MEMORANDUM

To: The Design Advisory Board
From: Mary O'Neil, AICP, Principal Planner
RE: ZP 18-0505CA; 26 Park Street
Date: January 9, 2018

Applicant/ Owner: Lawrence Doane
Request: Remove rear appendage and porches; addition at rear; new porch and driveway, replace all siding, trim, and windows.

SITE PLAN
EXISTING
A.01

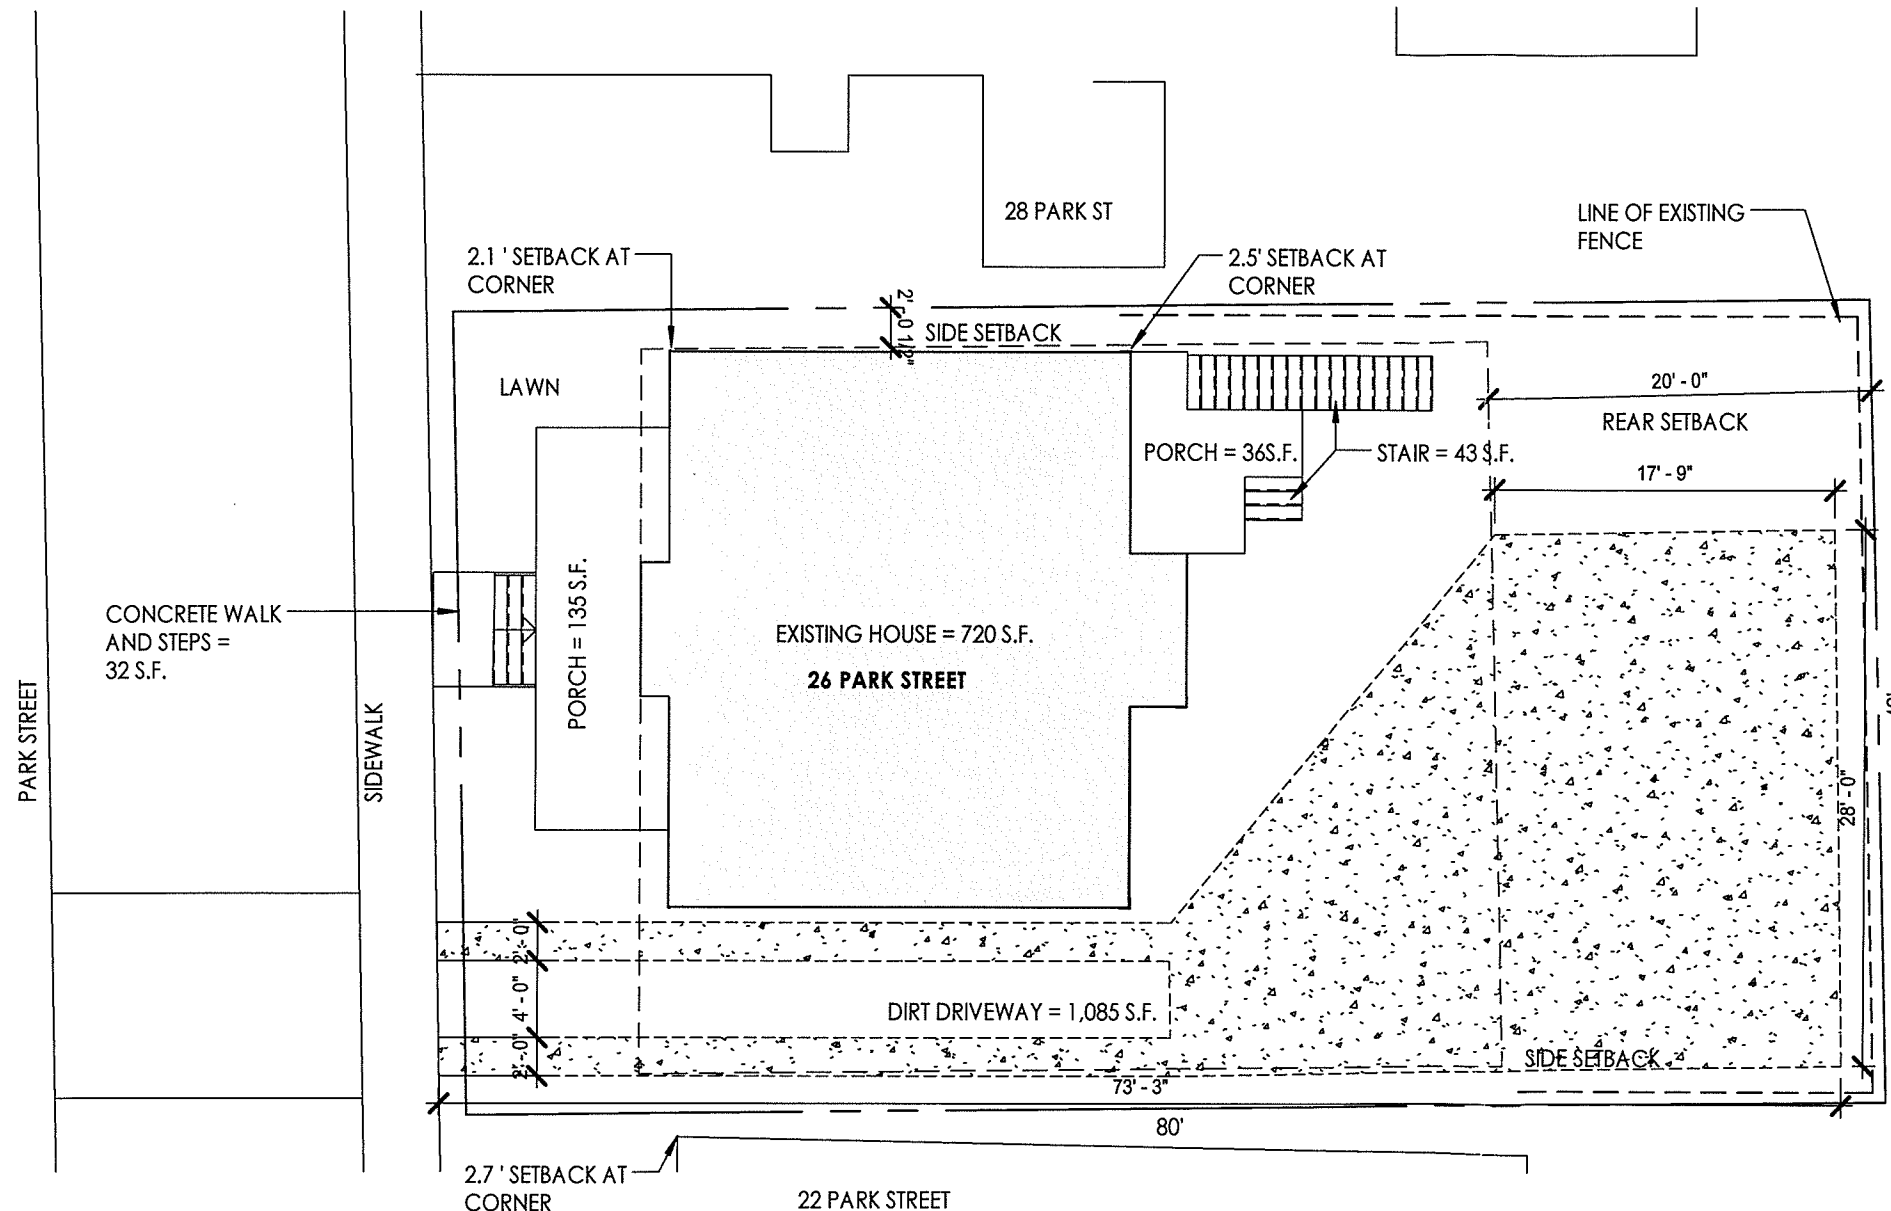
Two parking spaces are provided in the rear, adequate for a single family home. The required minimum 5' setback for parking areas (and patio) from boundary lines is not observed and must be. Adequate backup space is also not provided, but this parking arrangement is an existing condition (although undesirable as vehicles must back out onto Park Street.) As a single family residence the parking plan is acceptable; but if greater intensity of use is proposed, parking is insufficient and backup capacity significantly hindered by the small lot (3,360 sf.). Parking barriers will be required to prevent further parking creep toward and over property lines.

A 30" high fence is proposed to surround the front yard. See plan A.02.

1. Parking areas and patio must meet a minimum 5' setback from boundary lines.
2. Parking barriers must be provided to prevent parking lot creep. The choice must be identified and illustrated on plans for review and approval of staff.

WEST ELEVATION - PROPOSED

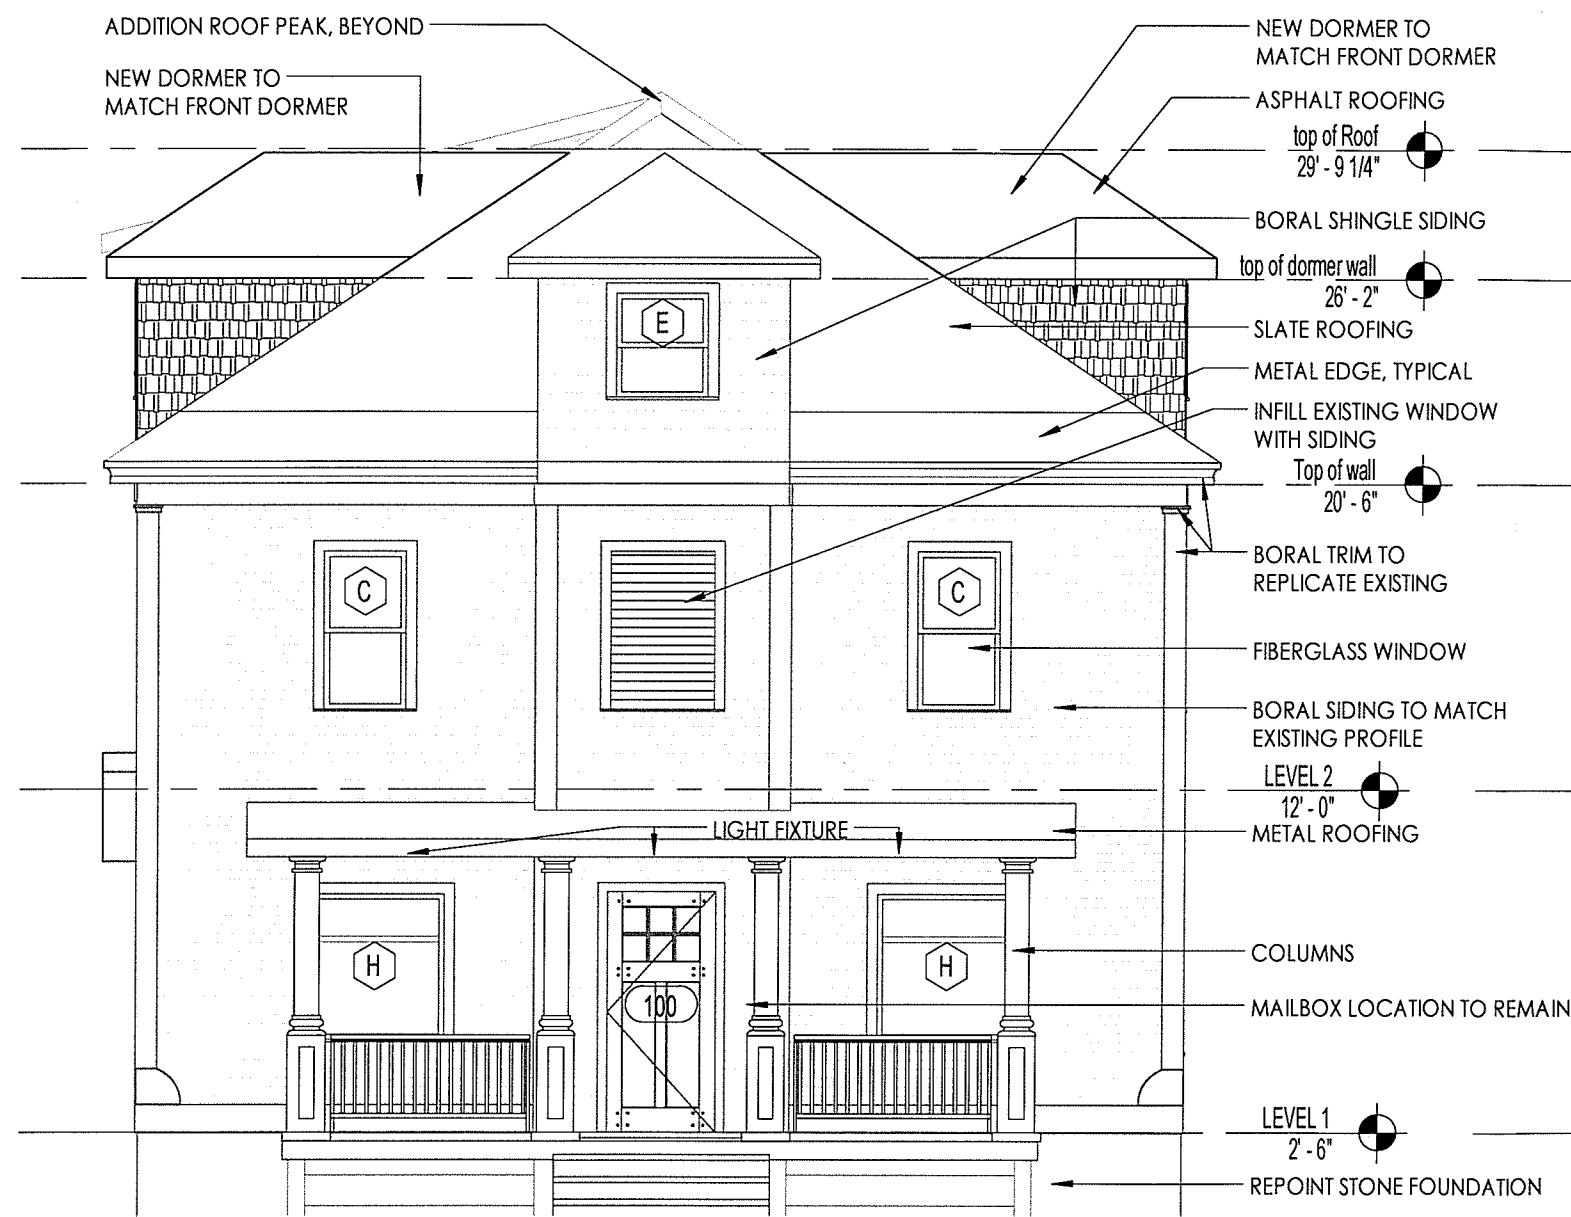
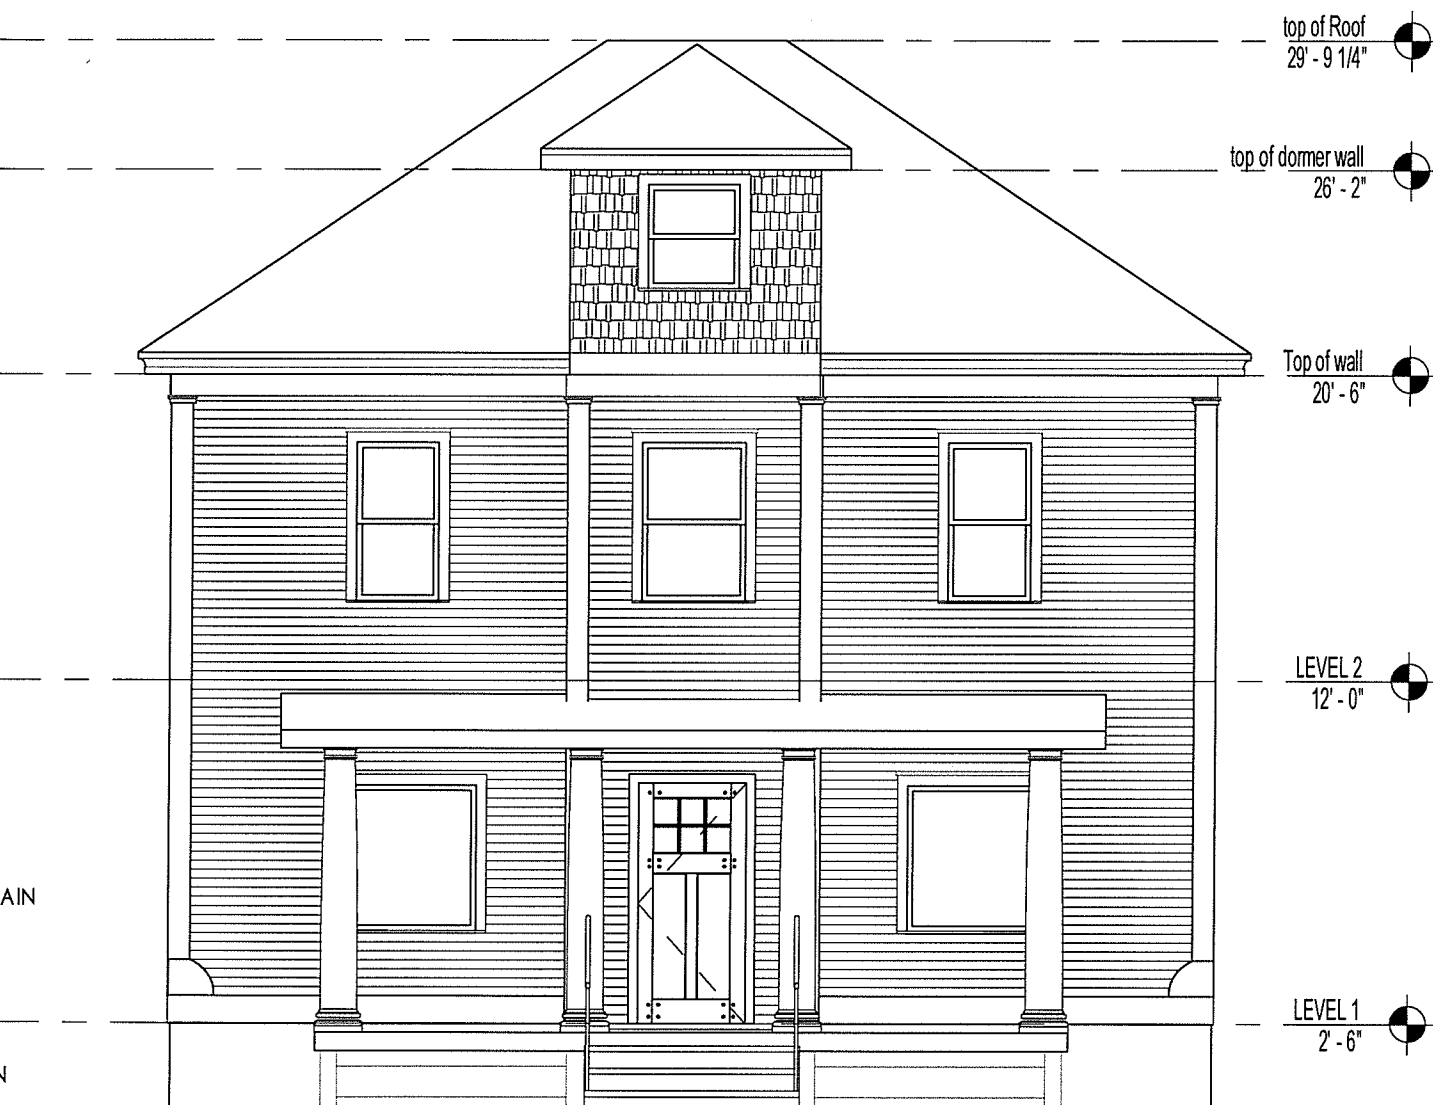
Prior decision of the Environmental Court and the DRB have not permitted fiberglass as replacement sash on historic structures, and have only allowed wood or clad wood as replacement when an original window is being removed. It is the applicant's choice for the rear addition. Fiberglass cannot be approved for the existing historic house.

Similarly, the application proposes replacement window, door, corner and fascia/cornice trim with a synthetic composite. The Development Review Board has specifically denied composite trim for historic porches. Fiberglass windows are not considered an appropriate replacement option for historic structures (new construction acceptable); wood or clad wood only are acceptable. The photo attached to the State Register listing appears to feature 3/1 windows on

NORTH ELEVATION - PROPOSED

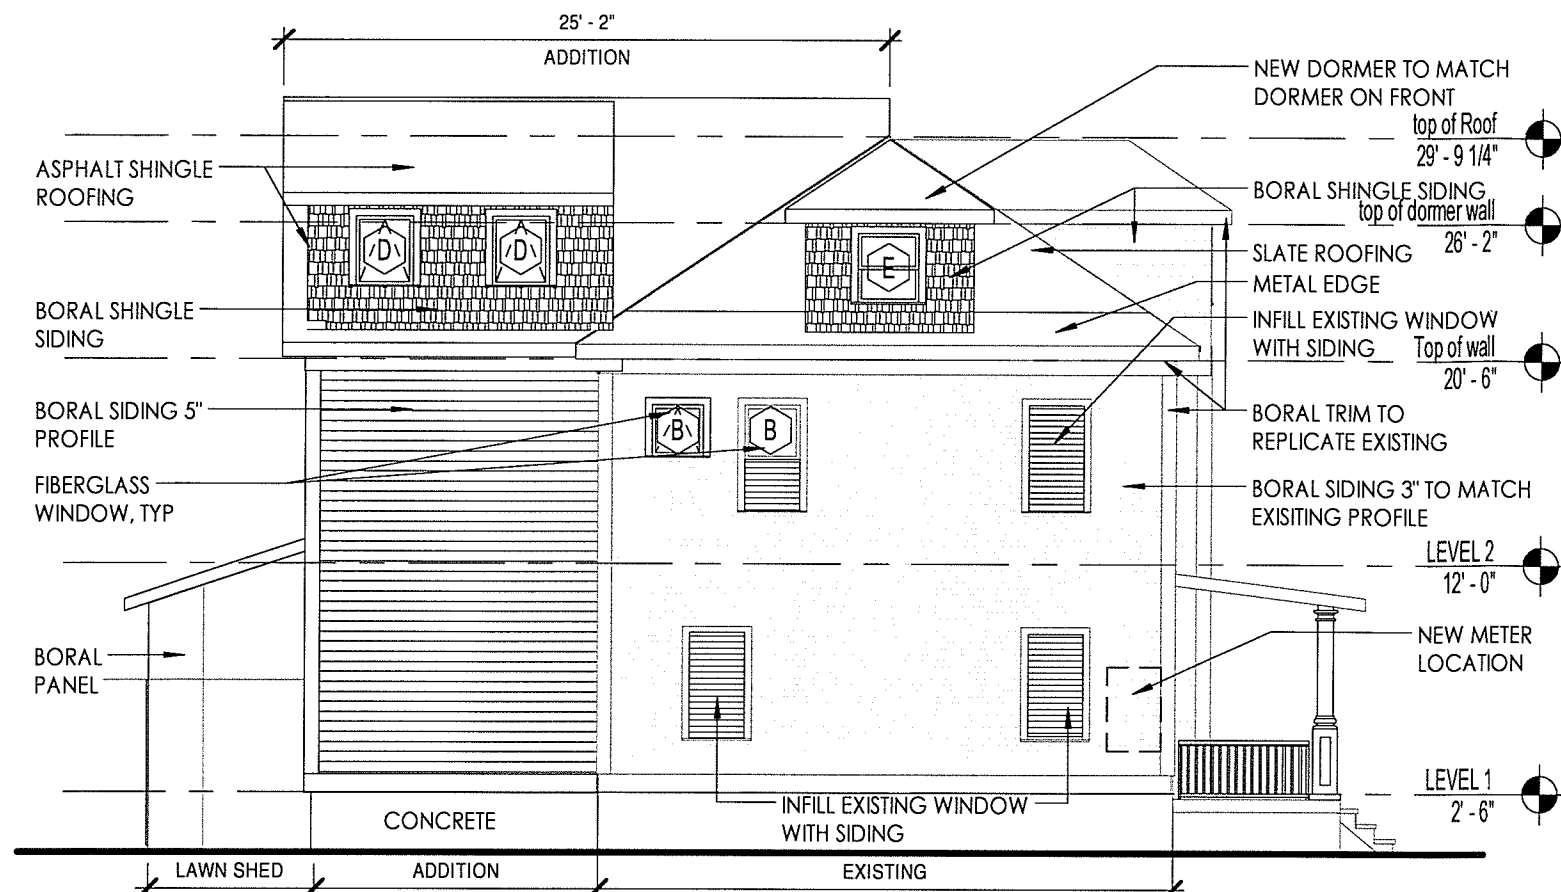
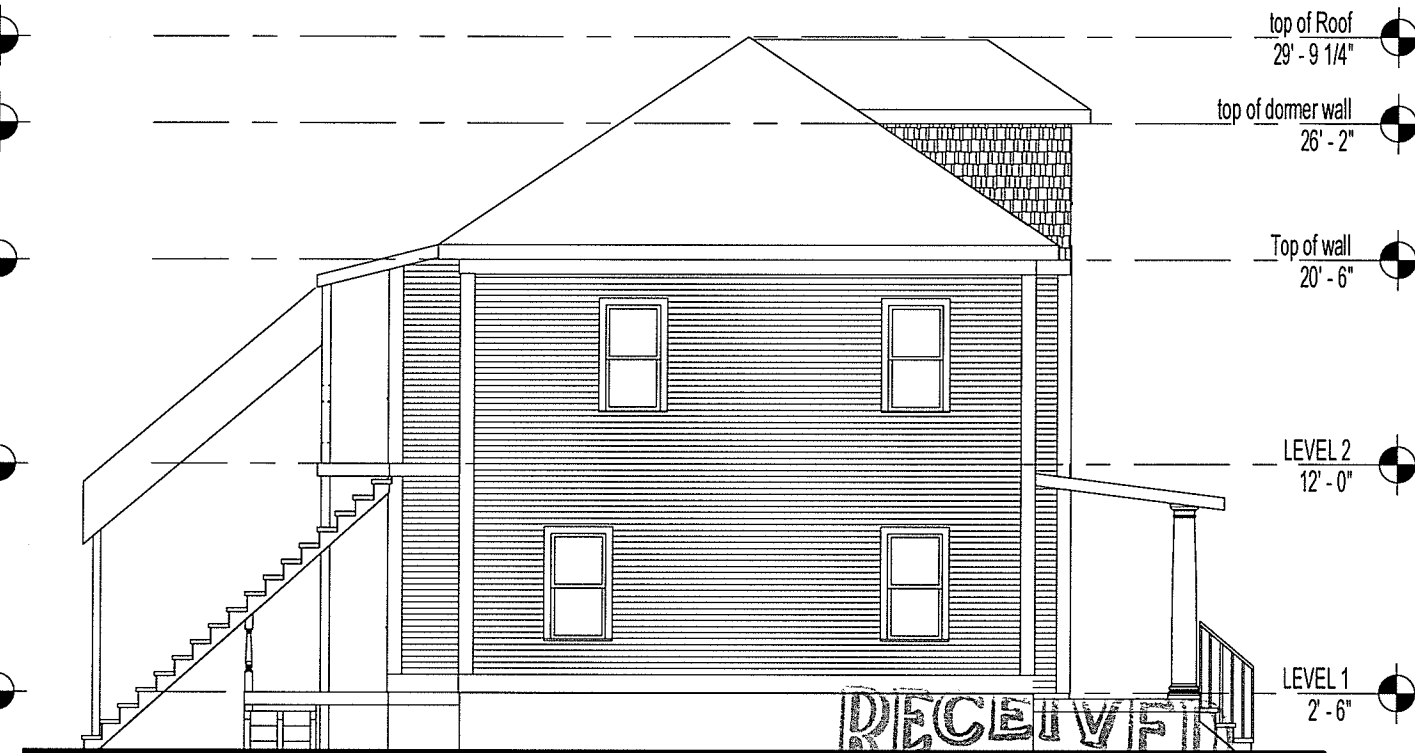
New windows in the addition are limited. Many of the existing original window openings are proposed to be boarded up, resulting in a dead looking building. No floor plan has been provided to explain the undesirable exterior appearance, particularly on the north elevation but notably on the face, fronting the Battery.

All images below depict Boral TruExterior® Bevel Siding

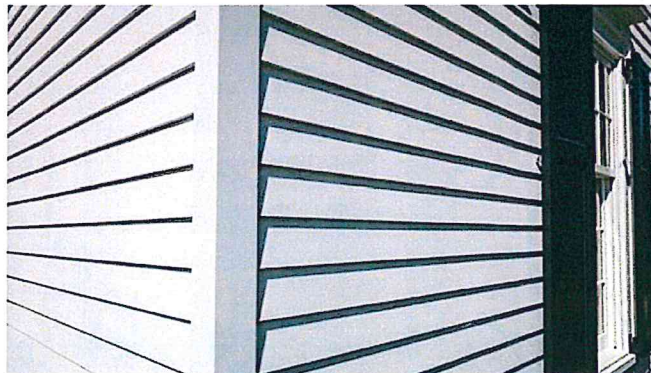
There is not enough documentation about the durability of the specific composite material ("Boral"). Metal roofing (porch) and asphalt shingles (rear porch roof and addition) are both acceptable for new construction. The metal roofing proposed on the front porch may initiate snow slide unfavorable for a primary entrance, creating a hazard for residents and guests.

Although the Environmental Court has permitted replacement of historic wood clapboard with fiber cement, they have not entertained the product presented ("Boral"). It should be noted that the earlier siding approval required that the reveal match that of the existing material; something that may be difficult with this product given such a small existing reveal dimension. Maintaining the historic reveal pattern is essential in maintaining the original historic character.
